621 Hillsborough Street
Suite 500
Raleigh, NC 27603
919. 361. 5000

**RE: The Point Phase Two, Six, and Nine Partial
Case Number: FSP-24-23
Response to 1st V1 Review Comments
AWH20000**

SHEET 2-7

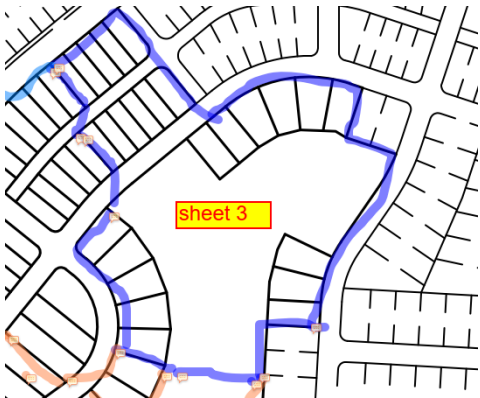
- 1. Add phase lines to all sheets so legal descriptions can describe Phase # and Lot #. Show limits of mapping or references to previous recordings for adjoining lots.

McAdams Response: Phase lines added to all sheets.

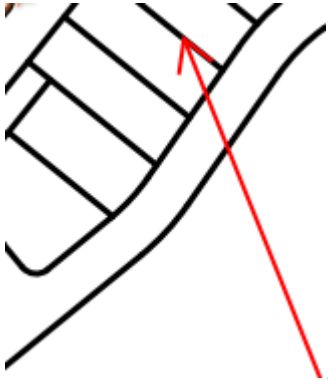
6. Add notations for sheet numbers (same as BM 2024, PG 2025).

McAdams Response: This has been labeled.

SHEET 3-7

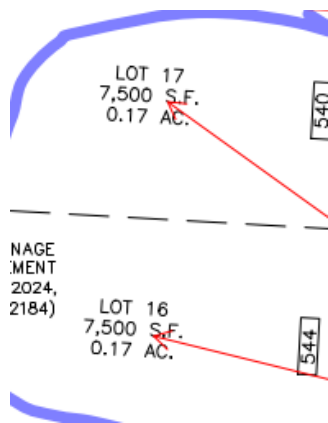
3. 9. Remove new from previously recorded items (all sheets).

McAdams Response: This has been removed.

SHEET 5-7

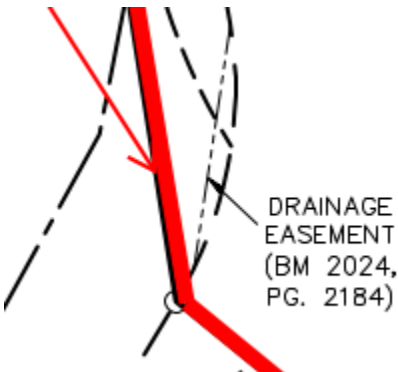
- 2. BM 2024 PG 2185 notes these property lines as hereby abandoned. Are these new property lines? If they are abandoned, please remove.

McAdams Response: These have been removed.

SHEET 6-7

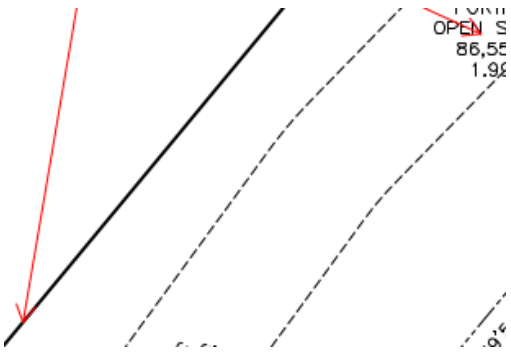
- 1. Please label all metes and bounds for the open space area.

McAdams Response: Bearing added to the line along the right of way, the northern line is not a property line.

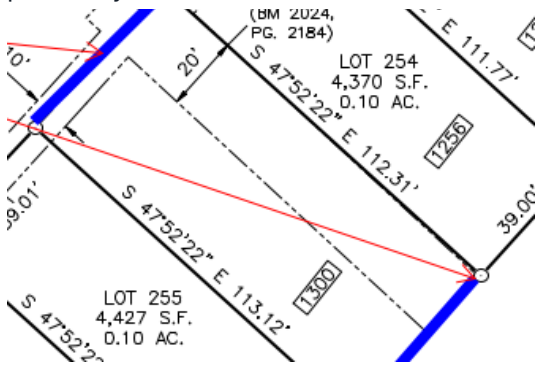
- 2. Please provide ties for these lot lines (required at these locations) Is this a lot, part of open space, or as it been previously recorded?

McAdams Response: Bearing added to the line along the right of way, the northern line is not a property line.
